Modification of Minister's Approval

Application No: 06_0225
Proponent: Hanson Construction Materials Pty Ltd
Approval Authority: Minister for Planning
Land: Lot 5 in DP1145808
Concept Plan: Hanson Asphalt and Concrete Production & Recycling Facility

Figure 1: Key components of the modified Concept Plan

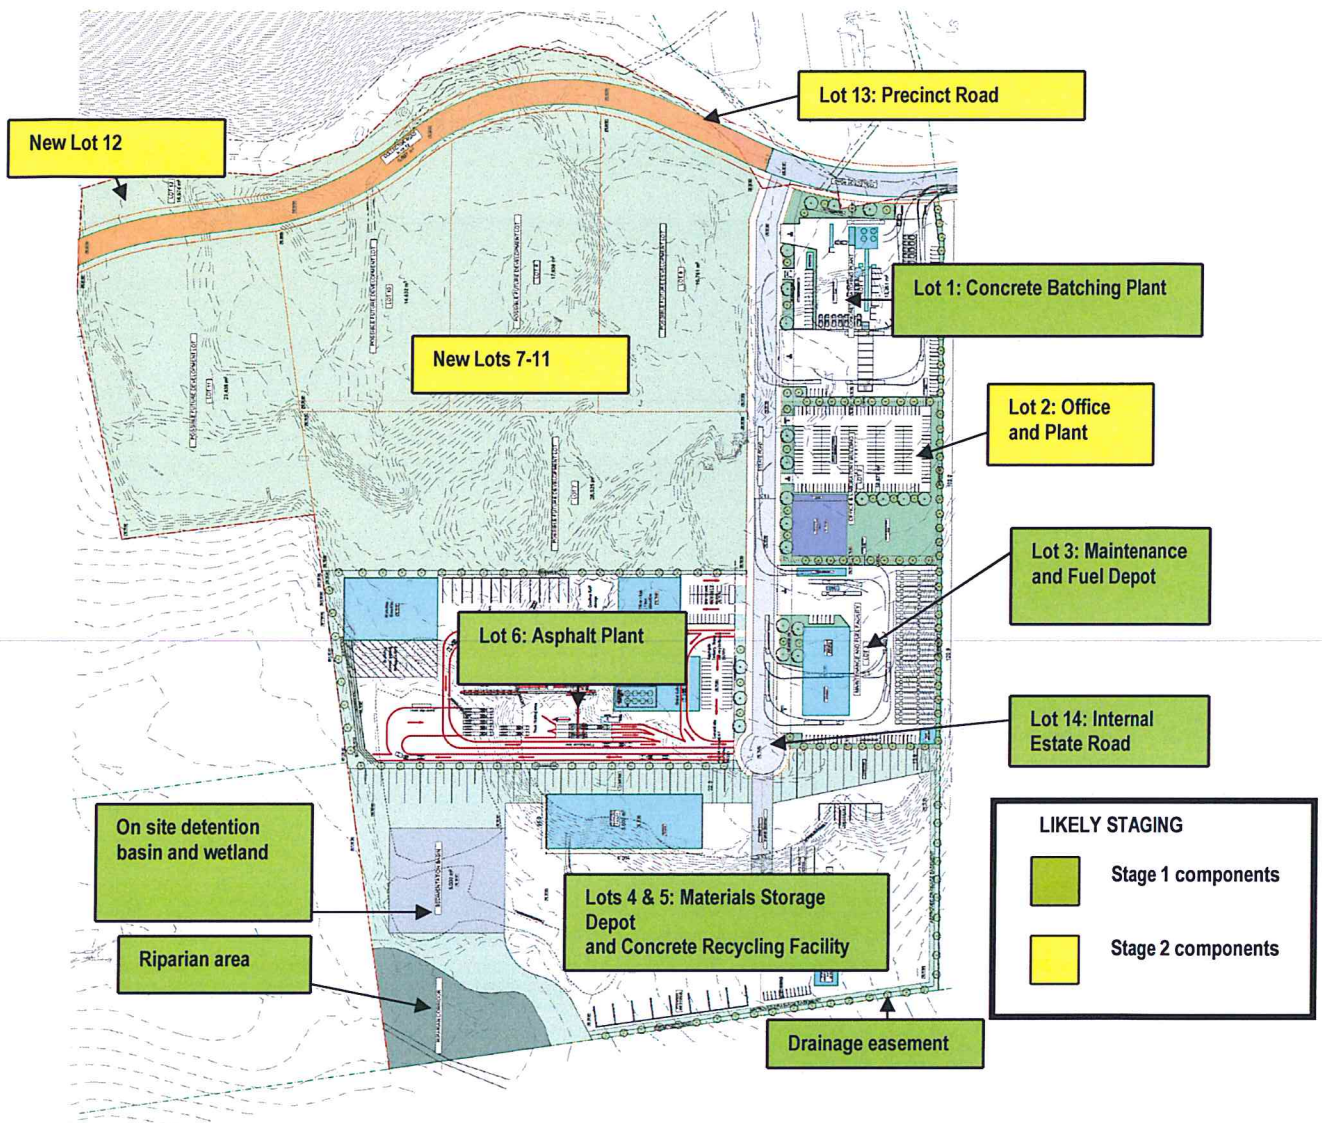
10. Replace Appendix 1 with the following:
